Objet : RE: GAN18505.1 - unusual PC-Test data

We seem to have a layout issue, with the placement of scribe line PCM structures in the Y08R reticle set. Y08R lots are failing all metal bridging & continuity tests, which are pad groups 18 & 19.

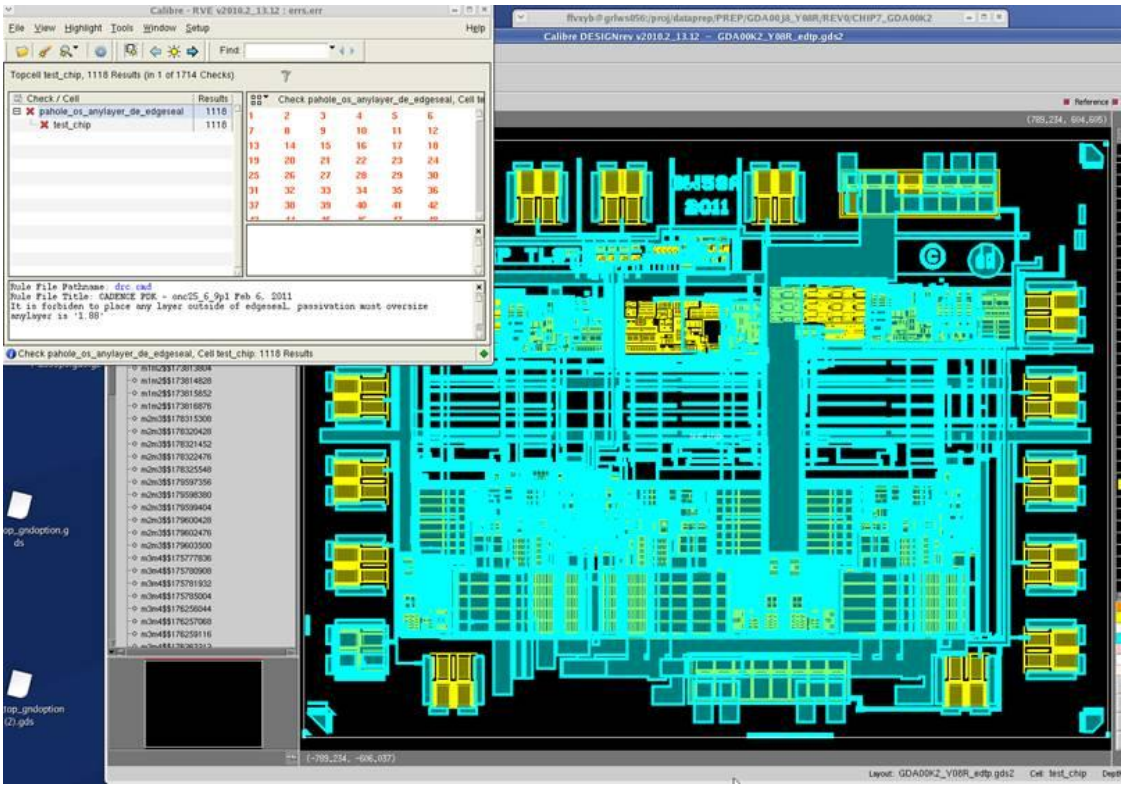
The DRC check below is intended to verify that ONC25 edgeseal exists, correct? If not, we need to create a check to verify that edgeseal is part of a product.

Can you explain the reasoning for using a non-standard edgeseal on NCP2815_Test chip 1 GDA00K2 Y08R? What was created is shorting the production PC-Test electrical monitors.

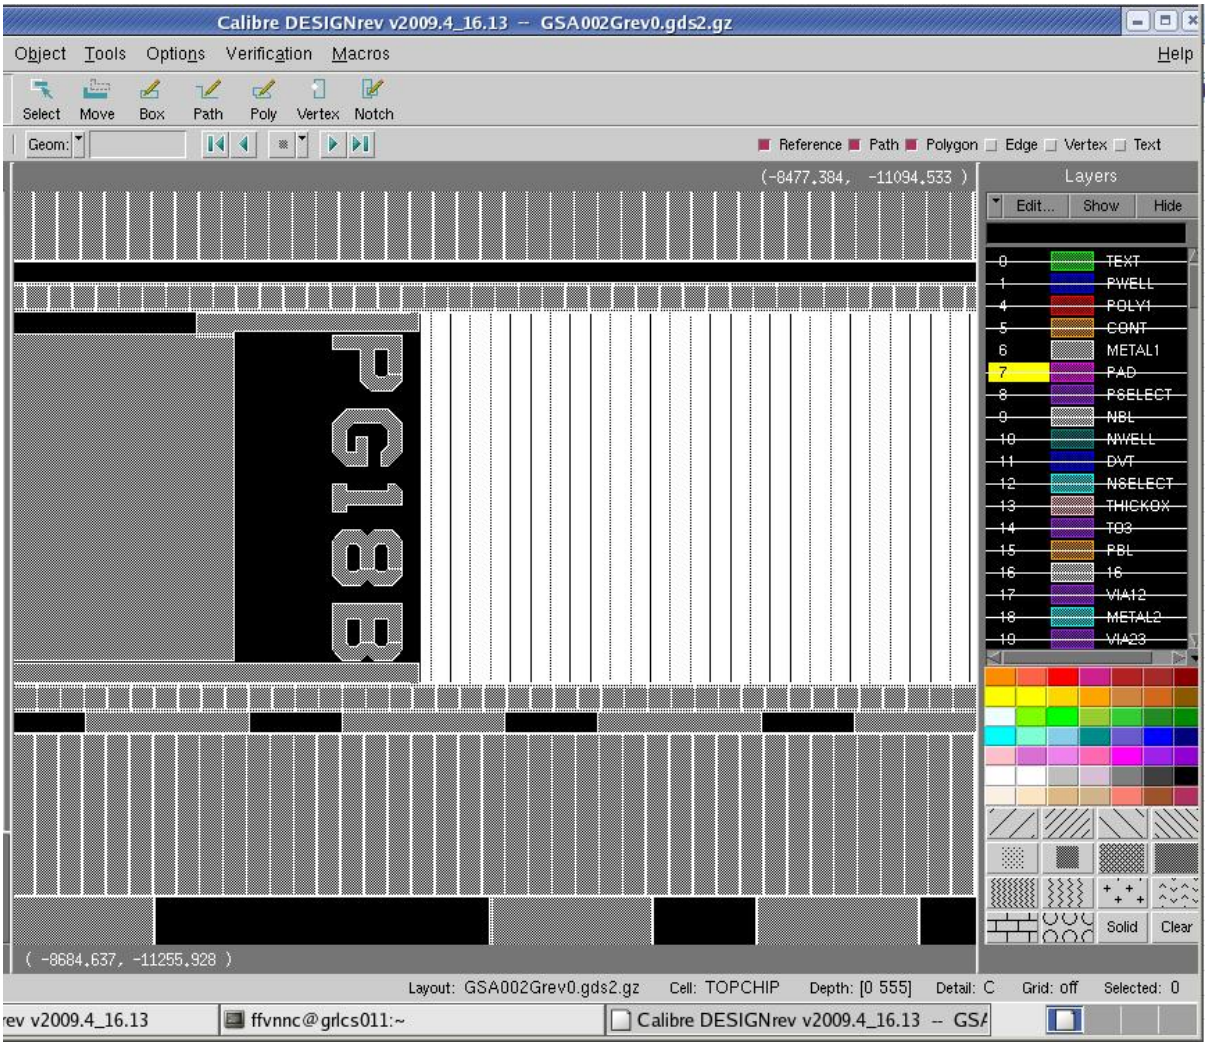
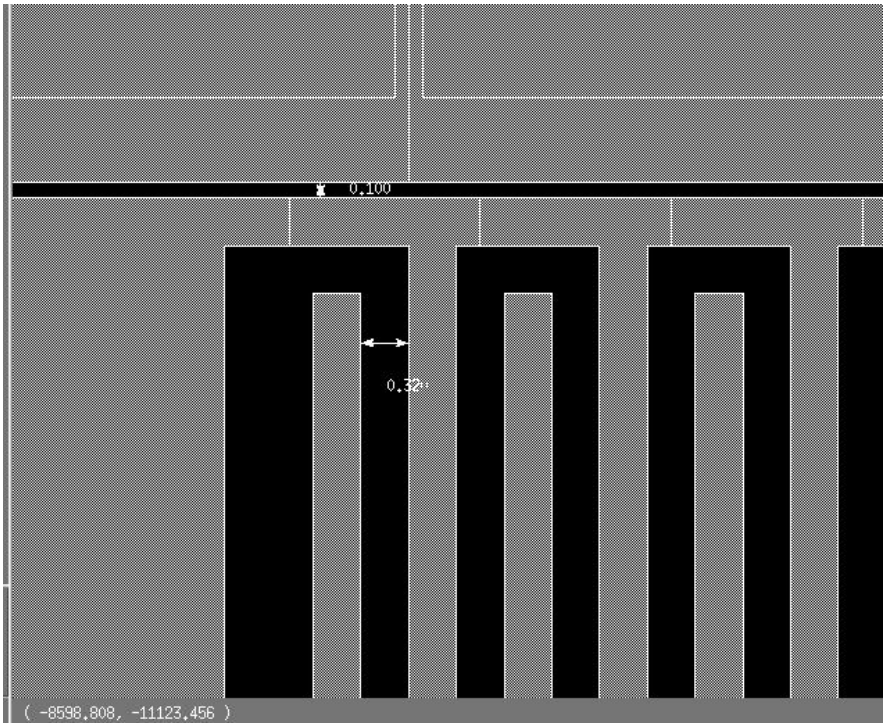
Reviewing the gds data shows sub-DR spacing alongside the m1comb (Metal 1 bridging) structure. The comb structure is fine (0.32um space) but alongside there is a 0.1um space.

The problem that you are seeing is the Y08R chip seems to have an edge seal that is not standard. When the process integration group had the PC-Test structures created they created them at 80 microns wide. The metal layers are allowed to run out to this width. They were depending on the die seal structure not to create shorts to the metal layers of the PC-Test structures. In the design kit seal ring the passivation defines the extent of the chip and the metal layers are a couple of microns in from there. In the case below the metal layers run all the way out to the extent of the chip.

When we run either a double wide scribe or an LVR type layout we assume the PC-Test structures are 85 microns wide not 80 so we do not produce shorts.

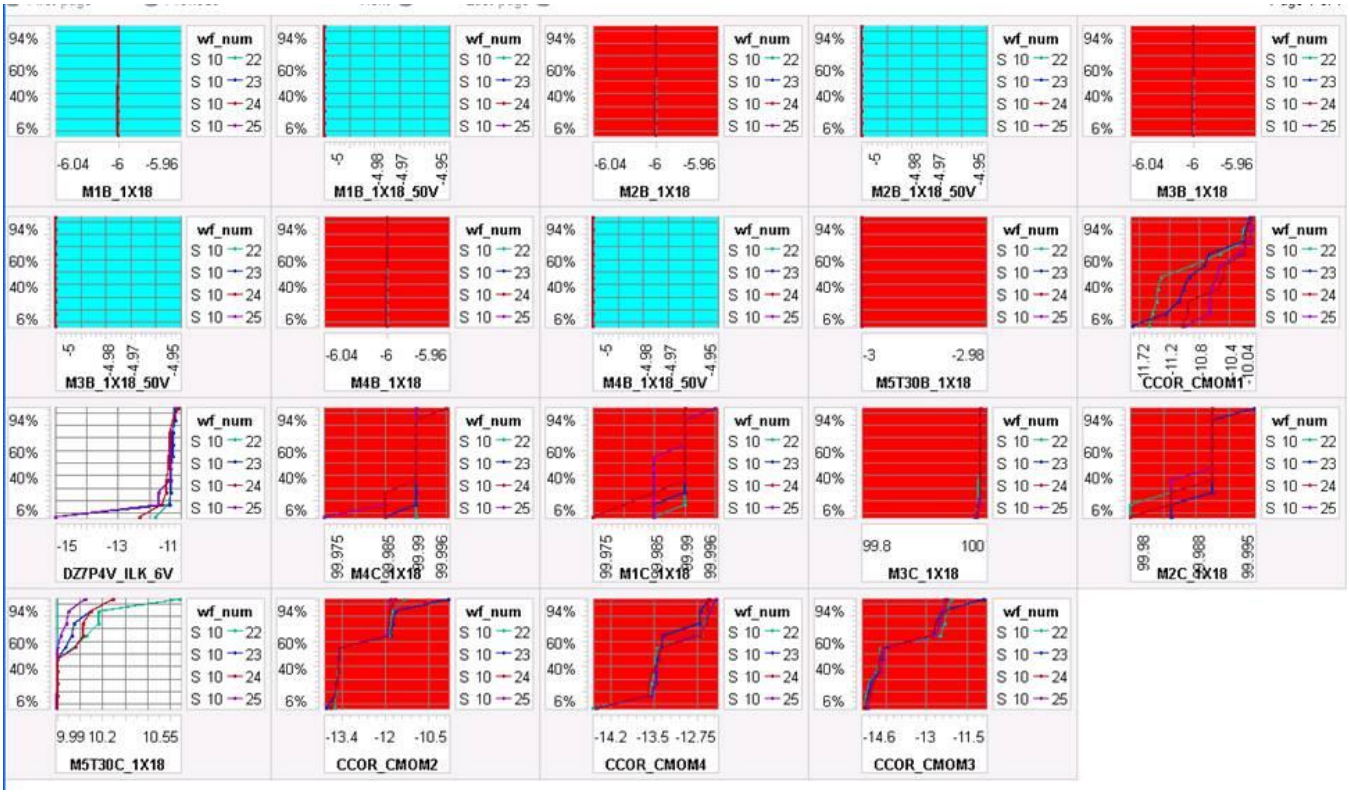
Hey Kim: I'm trying to figure out what's going on here. This lot is

Can you shine any light on these for me? If we truly were bridged, the FE would have the same catastrophic fails – and it doesn't.

Since this lot (wafers) failed M1B at M1 and EOL PC-Test (most likely different testers/probe card), the failure mode repeat and are real from a test perspective. It is odd that all of the metal bridging structures show railed leakage values. All of the continuity resistance tests are also shorted yielding railed results (to within the resolution of the tester). I think a review of the GDS for this product is in order.
